61-13-3 Schleicher Amdt. 299 Part 507
Federal Register June 24, 1961. Applies to
Model K-7 Gliders With Serial Numbers Up
To and Including 935 and Serial Number
984.

47-32-15 Sikorsky (Was Mandatory Note 1 of AD-2H-1.) Applies to Model S-51 Helicopters.

FIGURE 1

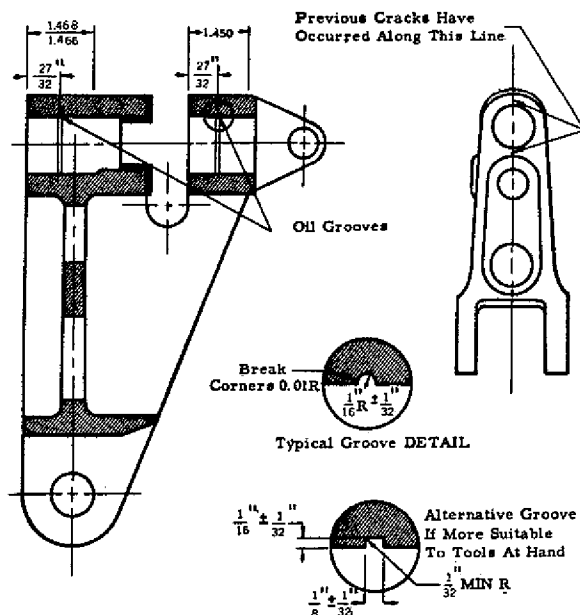
To reduce the possibility of loss of flight control due to failure of the main rotor links from lack of lubrication, the links should be reworked in accordance with the following instructions. This change involves the removal and inspection of main rotor link, P/N VS 36181 and machining of oil grooves.

2. Visually inspect main rotor links, P/N VS 36181 by one of the following methods for cracks around link pin hole and longitudinally along what was the flash line in original forging. (See Figure 1.) If cracks are present, links should be scrapped.

3. Machine oil grooves. (See Figure 1.)

FIGURE 2

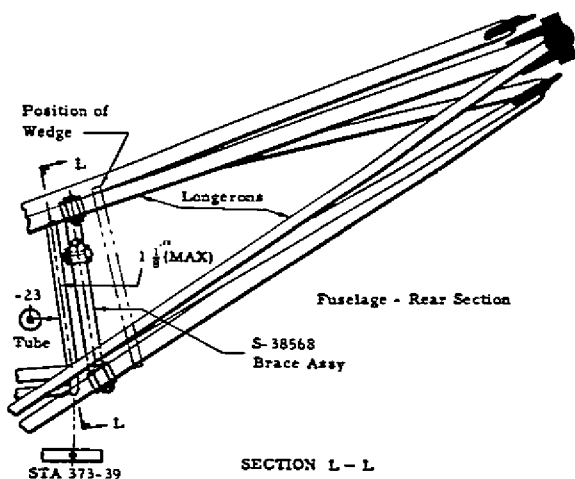
Sikorsky P/N S38566 and S38567, in telescopic position, to lower right longeron and upper left longeron. (See Figures 2 and 3.)

(2) Locate brace so that its center and that of vertical tube, P/N S38505-23, forward of it, are a maximum of $1\frac{1}{8}$ inches apart. (See Figure 2.)

FIGURE 3

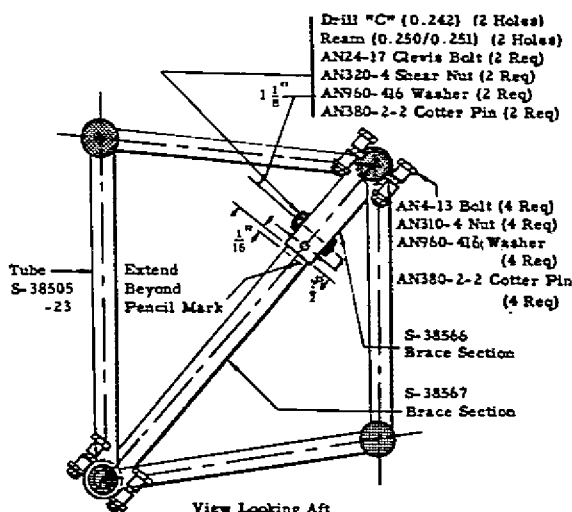
brace assembly, P/N S38566, on assembly P/N S38567. (See Figure 3.)

(e) With wedge securely in position, using drill No. 40 (0.098-inch), drill two holes through brace at 90° to each other. (See Figure 3.)

FIGURE 4

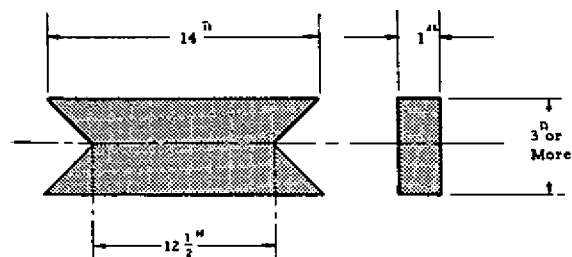
(c) Fashion a wedge, using a piece of wood 1 x 3 x 14 inches, and "V" notch both ends. (See Figure 4.)

FIGURE 6

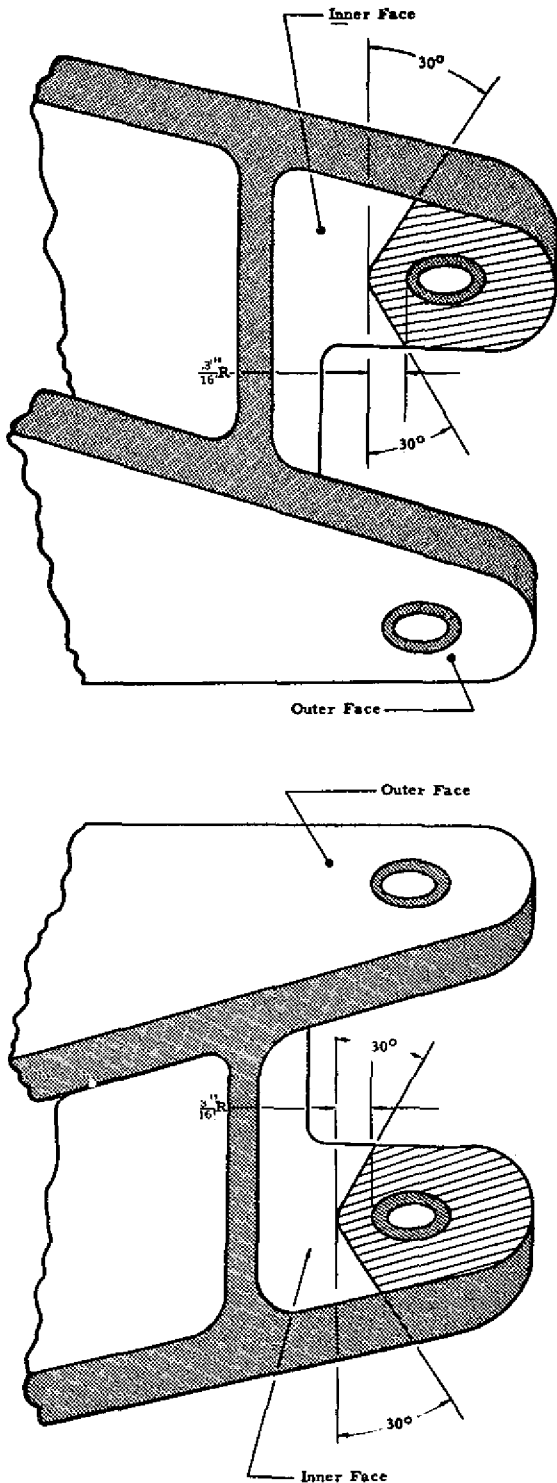
Inspect all main rotor link assemblies (P/N S510348) received from the manufacturer between June 1 and September 6, inclusive for location of the identification stamp "F". Links with the "F" metal-stamped in the critical area on the inner faces of the ears should be retired from service. Those with the "F" stamped on the outer faces or on noncritical areas of the inner faces of the ears should be polished locally with emery and crocus cloth to remove the "F" and the links may be returned to service. (See Figure 6.)
